**TOWNSHIP OF SOUTH WHITEHALL
LEHIGH COUNTY, PENNSYLVANIA**

PLANNING COMMISSION

MAY 9, 2024

A G E N D A

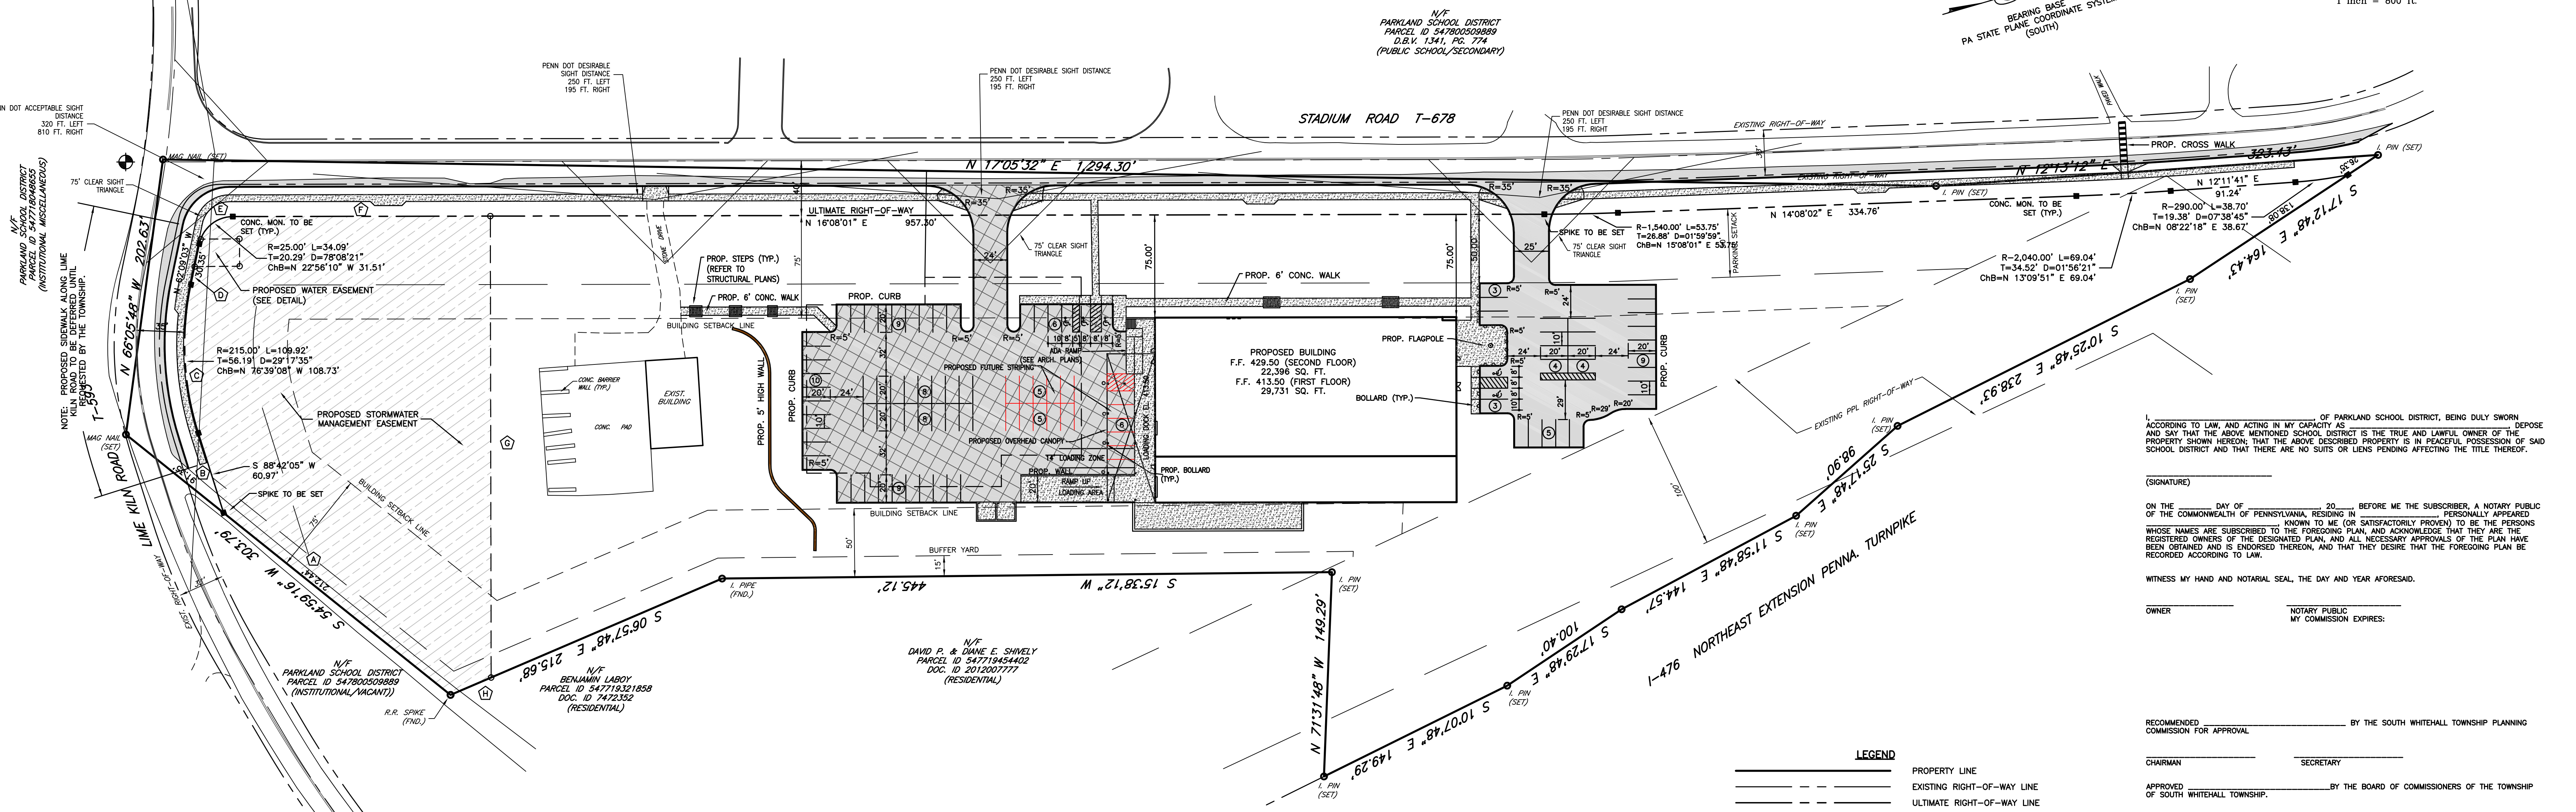
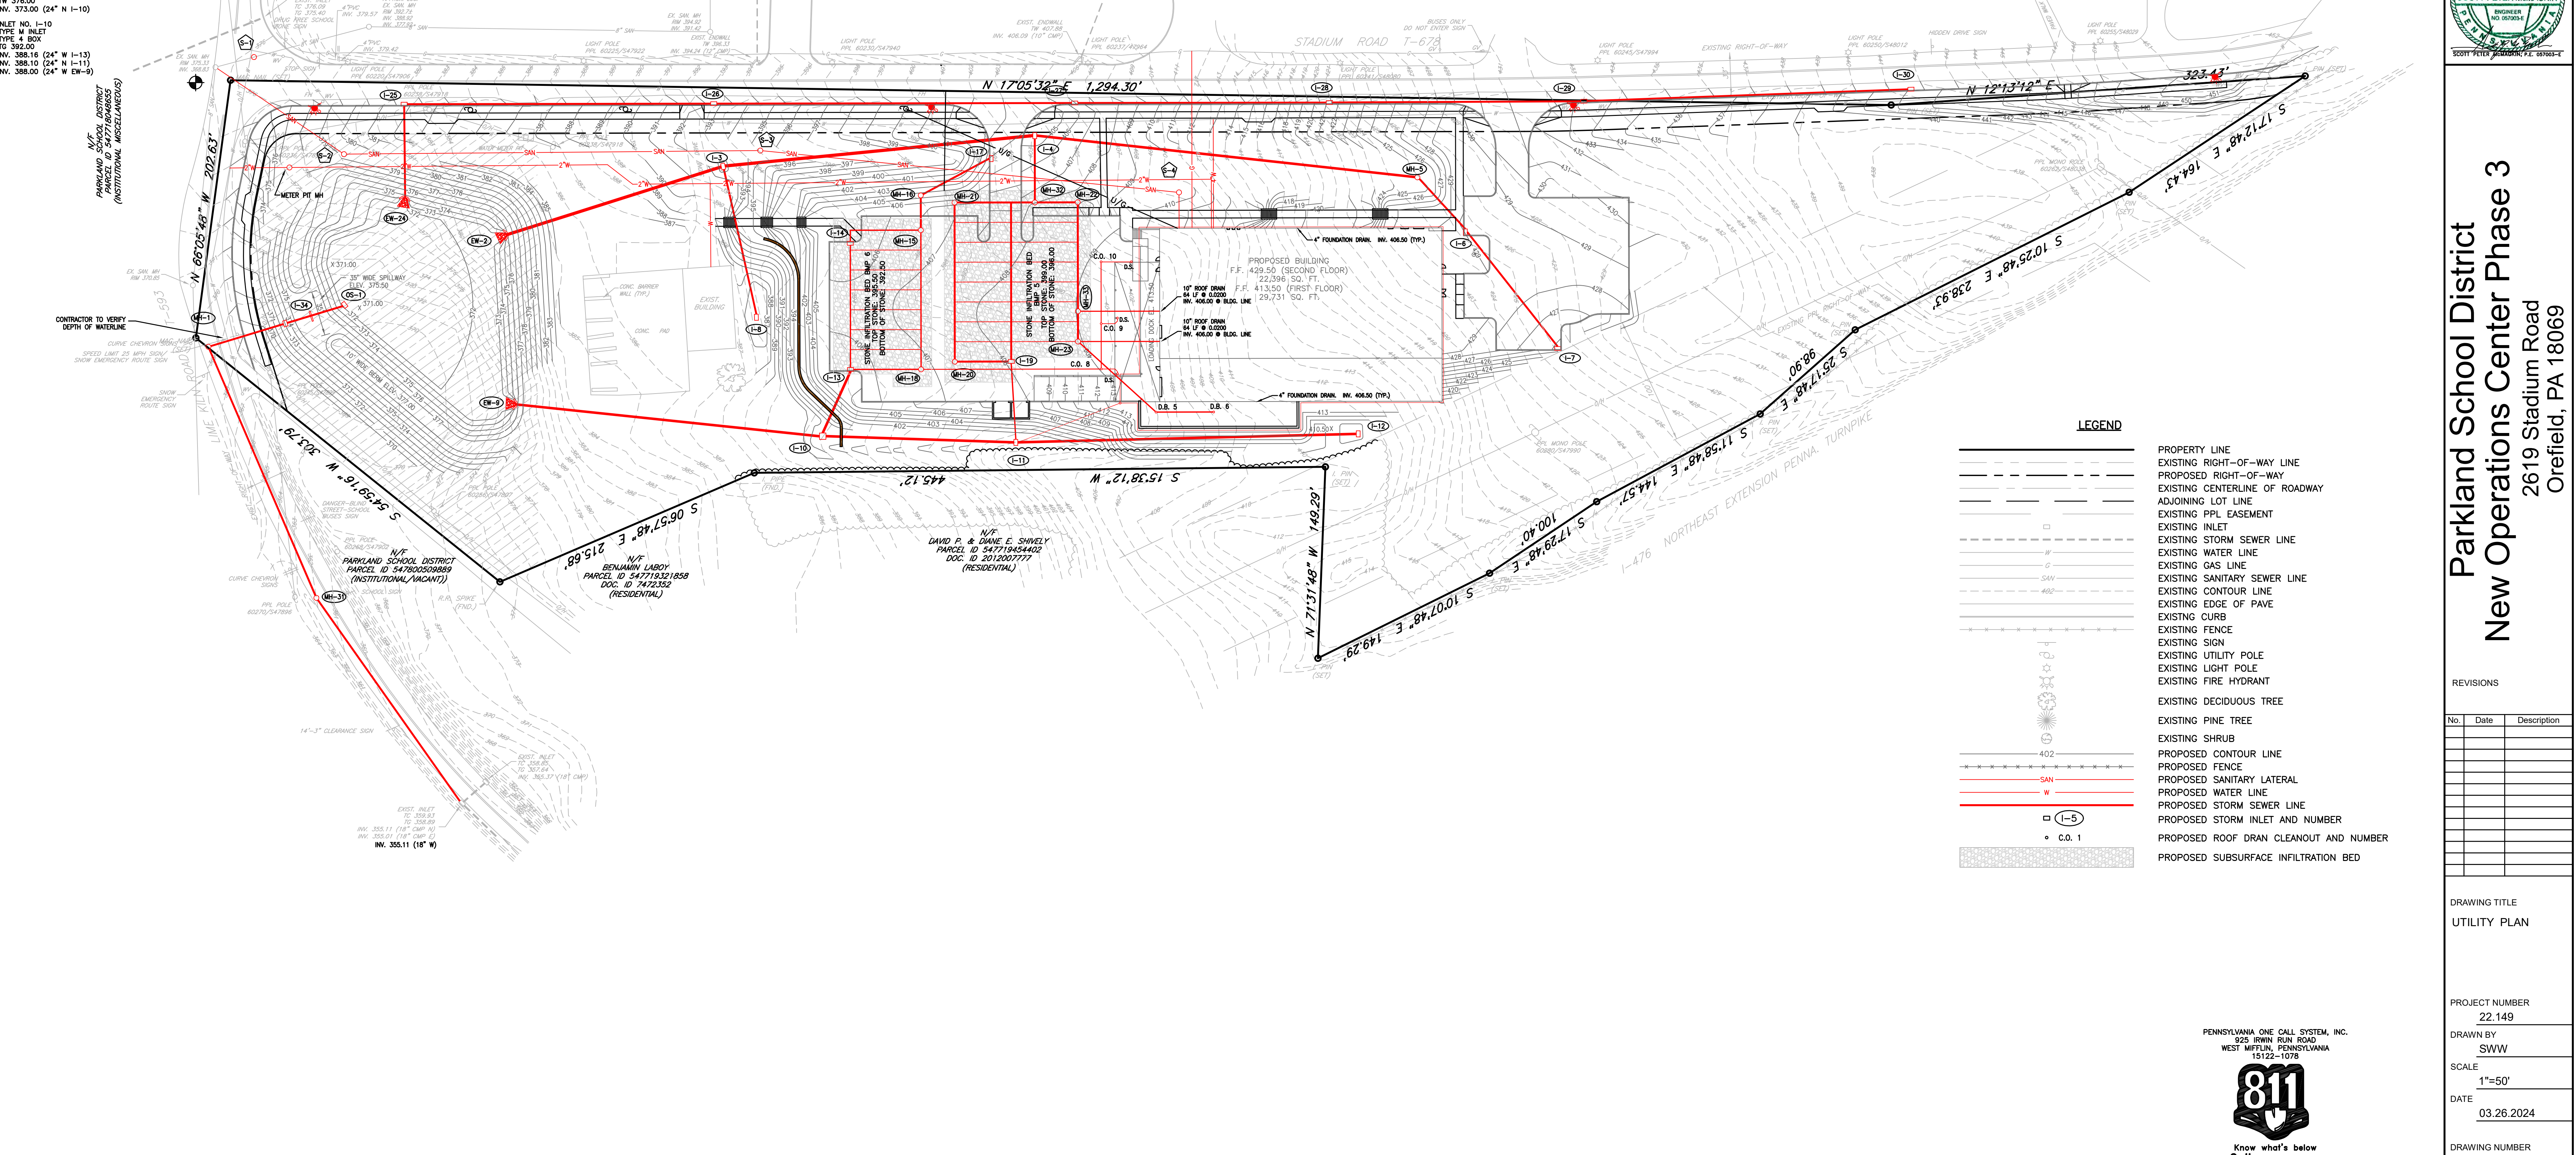
1. Per the Project Narrative, there is no additional site work, therefore no additional impervious surface is proposed. The Maximum Impervious Surface line within the Zoning Compliance Chart on plan sheet SP-1 shall be revised so that the Existing Conditions reflect the Maximum Impervious Surface as approved on the PSD New Operations Center plan set, reflecting the net increase in impervious surface proposed by Phase 3. Should no additional impervious surface be proposed, the fee in lieu of land dedication to be charged is \$0.00.
